DATE: **MAY 22 2003**
REPLY TO
ATTN OF: ERD:DCS/03-DEC-0001
SUBJECT: 116-N-1 EXPLANATION OF SIGNIFICANT DIFFERENCE (ESD), 100-NR-1
OPERABLE UNIT

**Explanation of Significant Difference
April 2003**

**EXPLANATION OF SIGNIFICANT DIFFERENCE
FOR THE 100-NR-1 OPERABLE UNIT TREATMENT, STORAGE, AND DISPOSAL
INTERIM ACTION RECORD OF DECISION AND
100-NR-1/100-NR-2 OPERABLE UNIT INTERIM ACTION RECORD OF DECISION
April 2003**

Figure 2. 116-N-1 Conceptual Subsurface Cross Section.

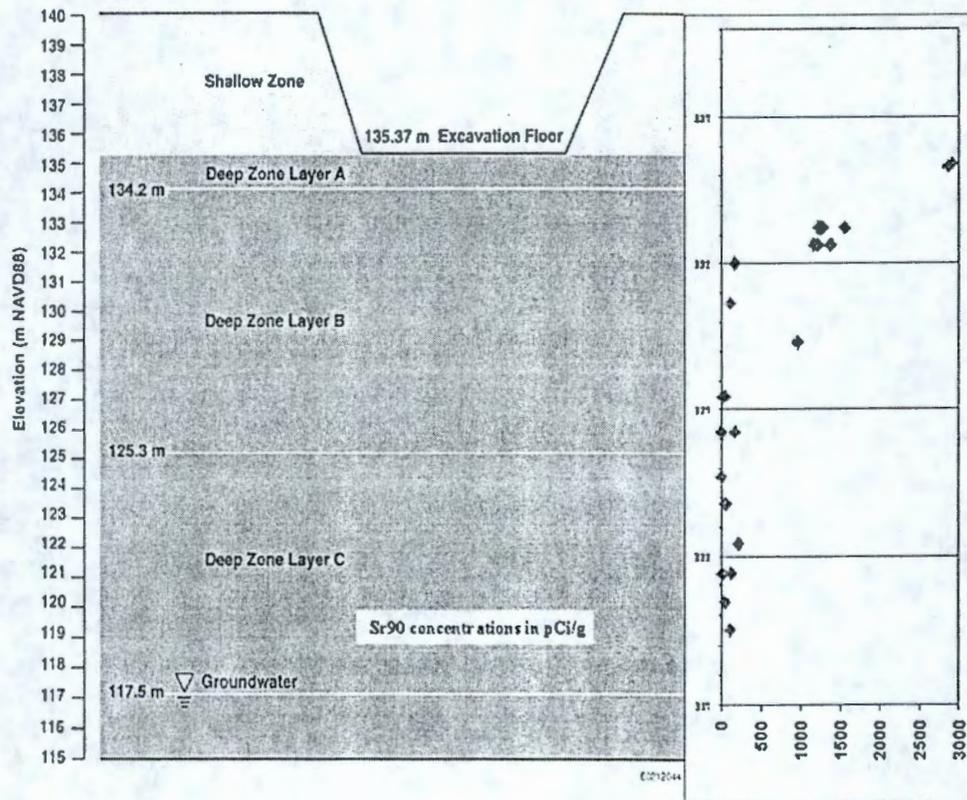
Figure 2 shows a conceptual model of the 116-N-1 waste site. Based on the application of RESRAD, the waste site is divided into three separate layers for modeling to demonstrate compliance with the RAOs. "Layer A" averages approximately 1,802 pCi/g of strontium-90. "Layer B" averages approximately 791 pCi/g of strontium-90, while concentrations in "Layer C" average approximately 78 pCi/g of strontium-90. The average strontium-90 concentration in the excavation area above Layer A is 2,597 pCi/g, which will be removed and disposed. The RESRAD modeling results show that soil contamination only in Layer C (Figure 2) would cause strontium-90 to exceed the MCL for protection of the groundwater. The MCL for strontium-90 in the groundwater is 8 pCi/L, and the RESRAD model calculates a discharge concentration of strontium-90 to the groundwater interface of 37.5 pCi/L. Based on these results, excavation would need to continue an additional 20 m (65 ft) to the groundwater table to remove Layer C. No additional radionuclides or chemicals remaining in Layer A, Layer B, or Layer C would exceed the standards for protection of groundwater.

The RESRAD modeling indicated that the lowest soil column layer beneath the 116-N-1 waste site (Layer C, Figure 2) contributes 37.5 pCi/L of strontium-90 to the groundwater, which exceeds the 8 pCi/L MCL for strontium-90 if 76 cm (30 in.) of irrigation per year is presumed. However, applying the RESRAD model without presuming irrigation shows strontium-90 levels leaching to the groundwater of 5.5 pCi/L, which meets the MCL of 8 pCi/L for strontium-90.

1. Add to the selected remedy, "DOE shall prohibit irrigation at the 116-N-1 waste site and eliminate irrigation from modeling at 116-N-1, based on the approved ESD, which identifies additional excavation greater than 4.6 m (15 ft) is not required."
